**MINOR MATERIAL AMENDMENT**  
2 Prince of Wales Road, London NW5

For London Borough of Camden  
September 2022

PLANNING PERMISSION 2021/4606/P

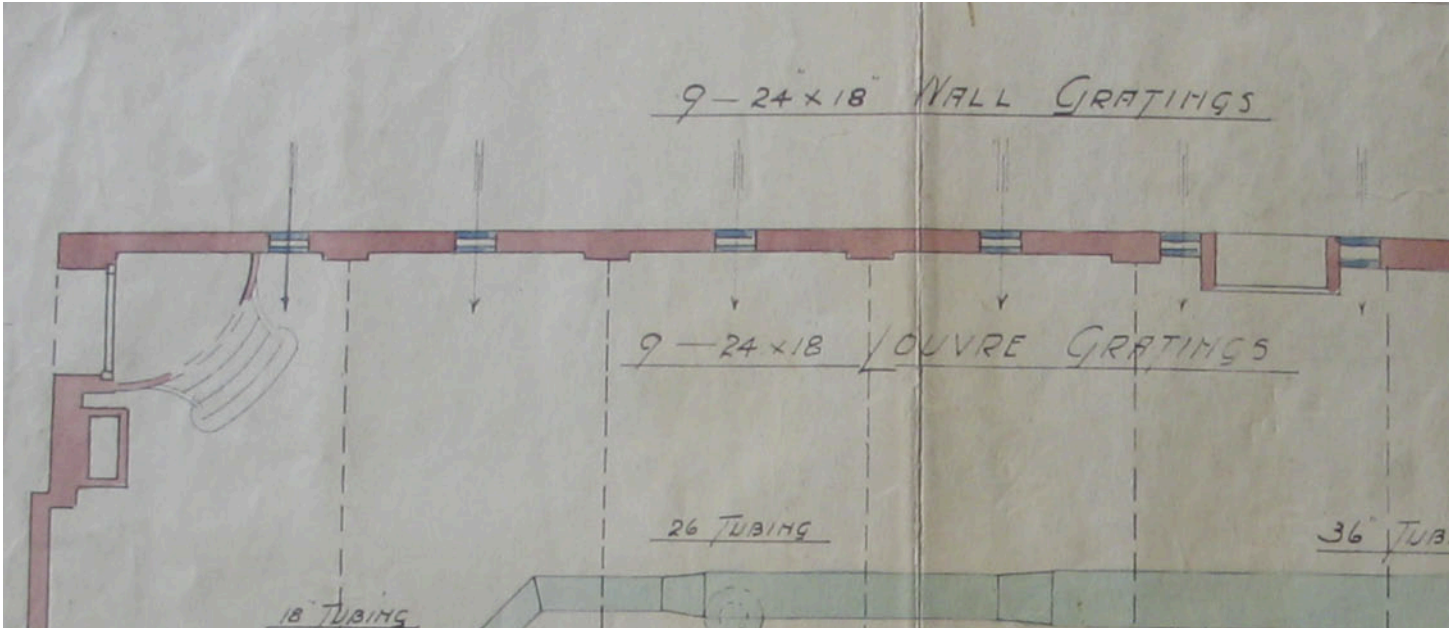
There are no drawings of the original design of the Grafton Yard elevation. There is however a photograph taken in 1973 which show the original vents in the elevation that are indicated on the original design drawings.

The 4ft circular louvres in the Grafton Yard elevation were for ventilation inlets.

Proposed Grafton Yard elevation viewed from Prince of Wales Road, showing proposed new ventilation turret and plant access opening (canopy and front elevation as planning approved scheme)

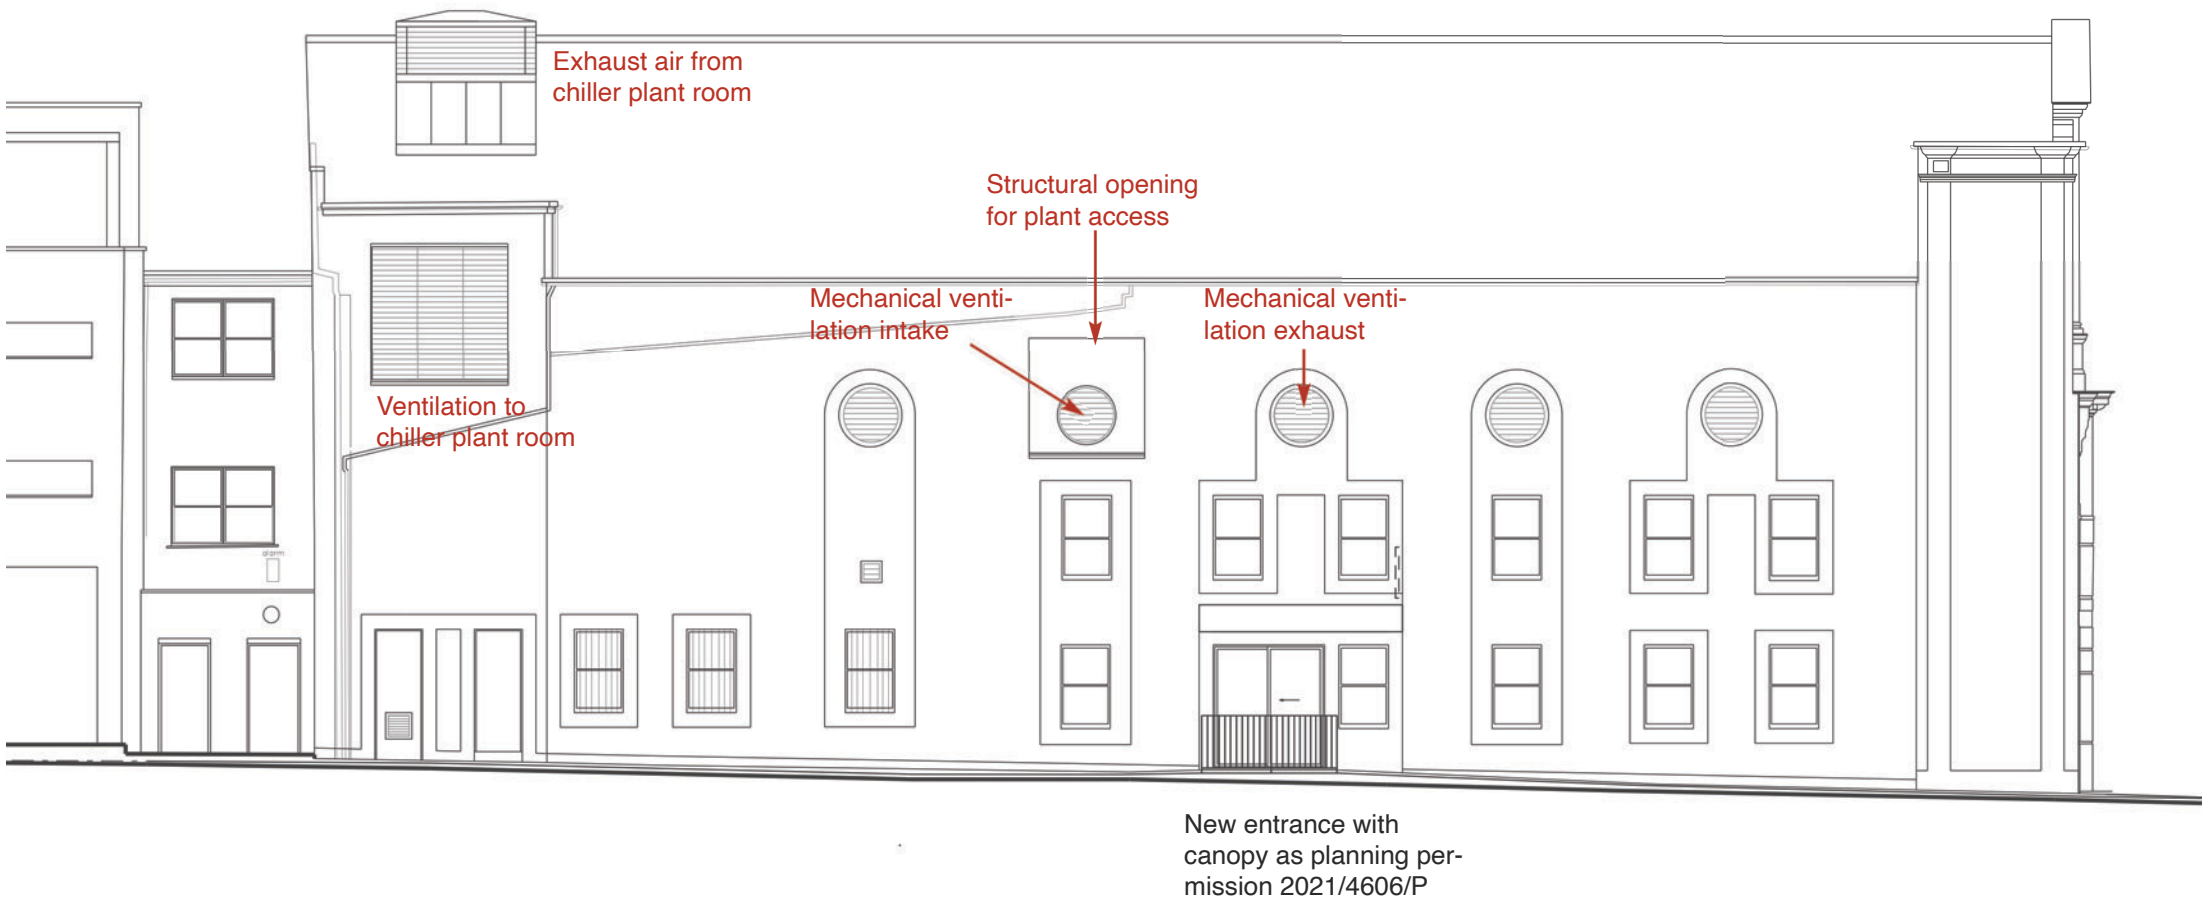
The roof line of the building at the north end also projects vertically to accommodate the ventilation to the balcony. It is proposed that the circular vent installed for this purpose is replaced with a larger opening to provide ventilation to the chiller plant room.

For this reason a mechanical ventilation system is required. The fresh intake and exhaust air is via circular grilles in the original ventilation openings. It is proposed that the other three opening have similar grilles to ventilate the roof spaces.

**VENTILATION FOR CONDENSERS**  
Condensers would normally be located externally, on a flat roof or external area. At 2 Prince of Wales Road there is no suitable external location and the condensers therefore have to be located within the building envelope. The large grilles to Grafton Yard and the rear elevation enable air into the chiller plant room, enabling the condensers to operate. The exhaust air is emitted via two turrets at roof level.

The main differences to the approved design is the addition of a large grille on the Grafton Yard elevation and the roof turrets.

*Roof turrets*  
The roof turrets are set well back from the eaves of the building and will not be significantly visible. The vertical weathering to the turrets will be in zinc cladding, a traditional building material similar to the metal cladding to the existing roof turrets at the south end of the building.

*Ventilation grilles to the chiller plant room*  
The proportions of the new grilles emphasise the vertical emphasis of the end bay of the building. This complements the tower-like element at the front of the building, which was part of the original services strategy the building.

*Plant Access panel*  
The rectangular rendered panel at high level above the new entrance is in keeping with the playful design from the 1980s, which provided window openings in Grafton Road elevation. The square proportions relate to similar elements in the elevations to rear of no. 205 Kentish Town Road, the front elevation of no. 2 Prince of Wales Road and the new entrance and canopy.
